PIER TOP PLATE INSTALLATION DIAGRAM FOR ATLAS TYPE MOUNTS

ADDENDUM

INSTALLATION DIAGRAM STANDARD PIER TOP PLATE

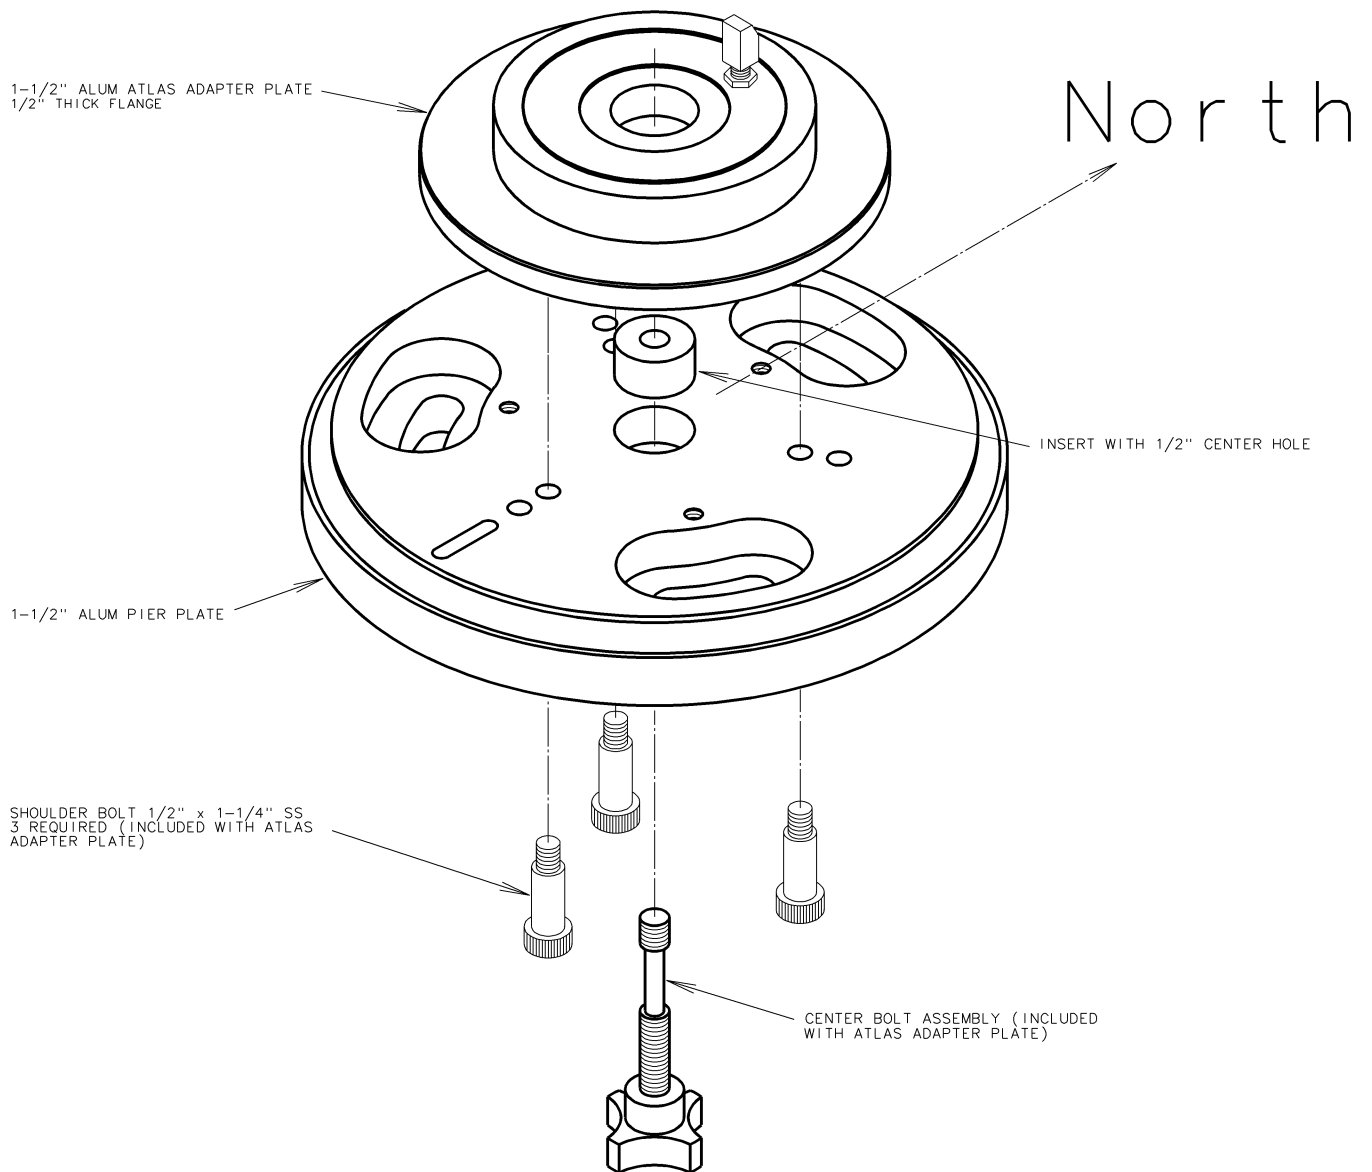
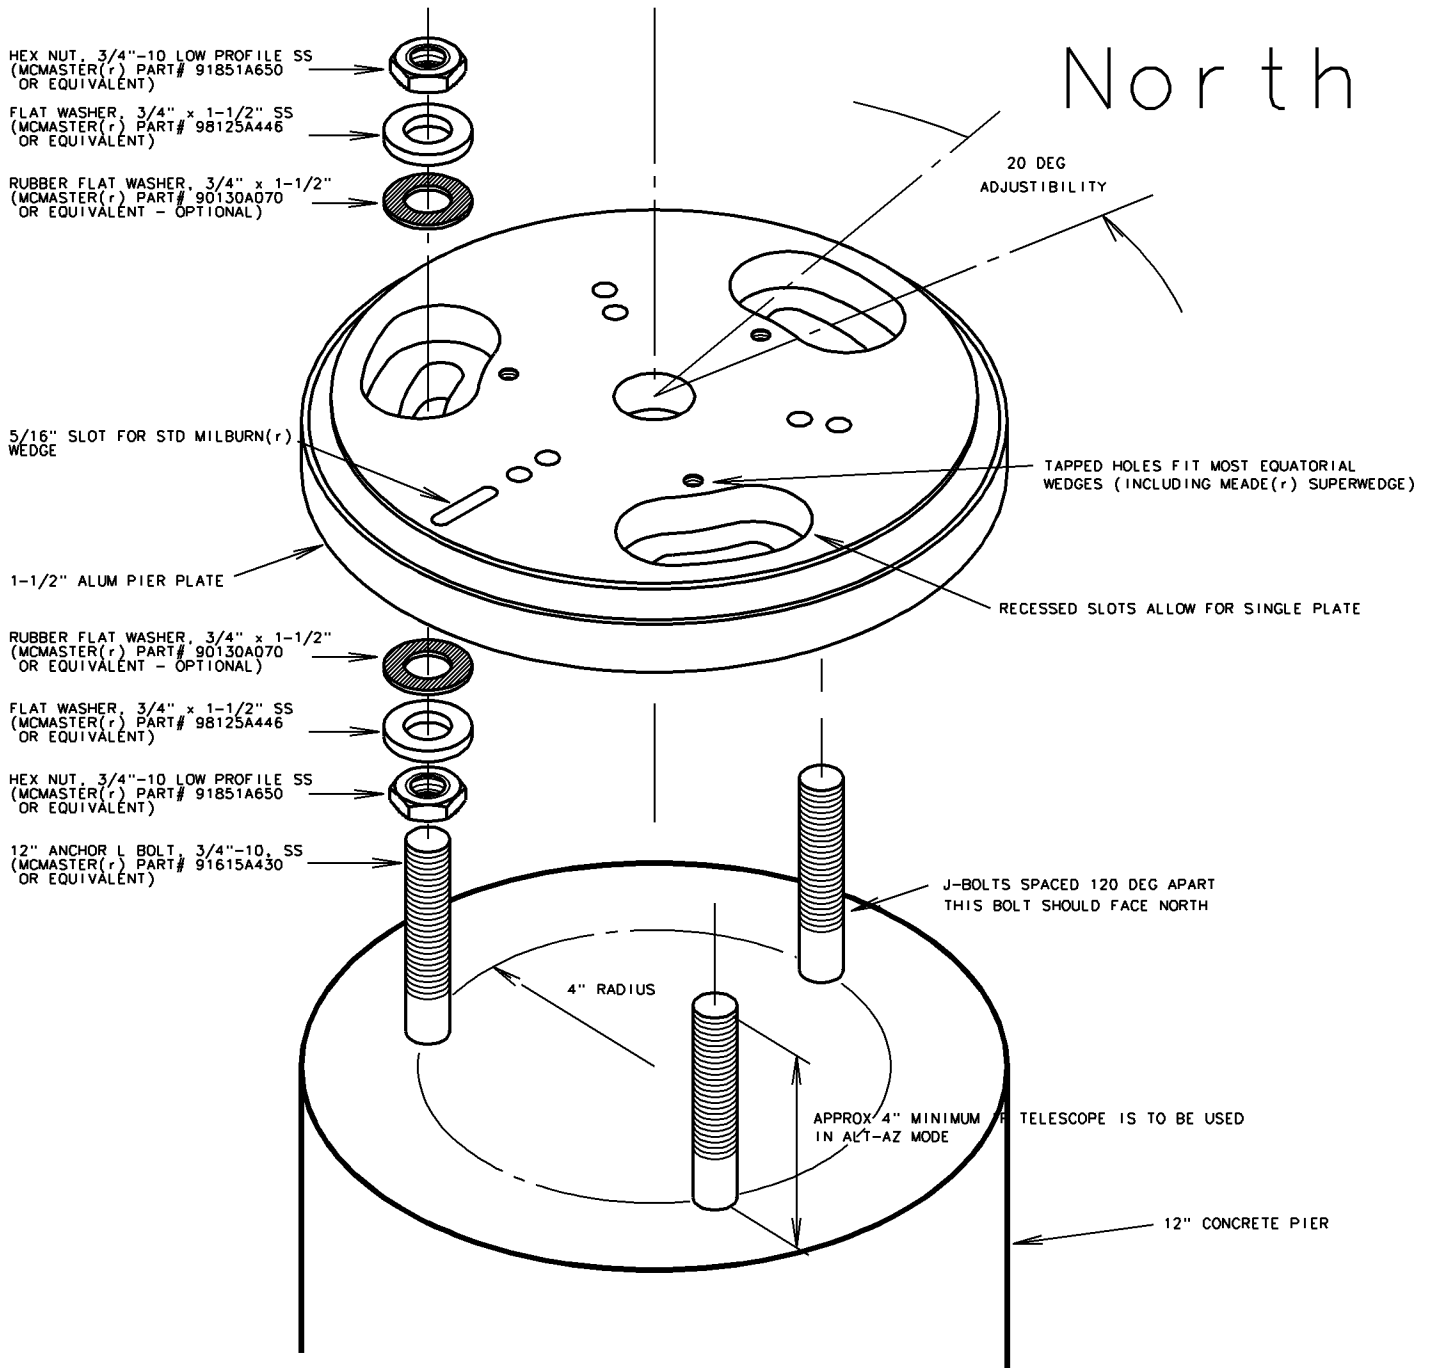
MANY CUSTOMERS HAVE ASKED US TO ENLARGE THE SIZE OF THE MOUNTING SLOTS OF OUR 12" PIER TOP PLATES TO MAKE UP FOR IMPERFECT BOLT ALIGNMENT. ALL 12" PLATES NOW HAVE WIDER MOUNTING SLOTS AND ALSO INCLUDE AN OPTIONAL BRONZE SLEEVE BEARING THAT SLIDES OVER THE ANCHOR BOLT TO PROTECT THE PLATE FROM THE ANCHOR BOLT THREADS. IF MORE LEEWAY IS NEEDED TO MOUNT THE PLATE, THE BRONZE SLEEVE BEARING MAY BE OMITTED.

BRONZE SLEEVE BEARING
(INCLUDED IN NEW 12" PIER
TOP PLATES)
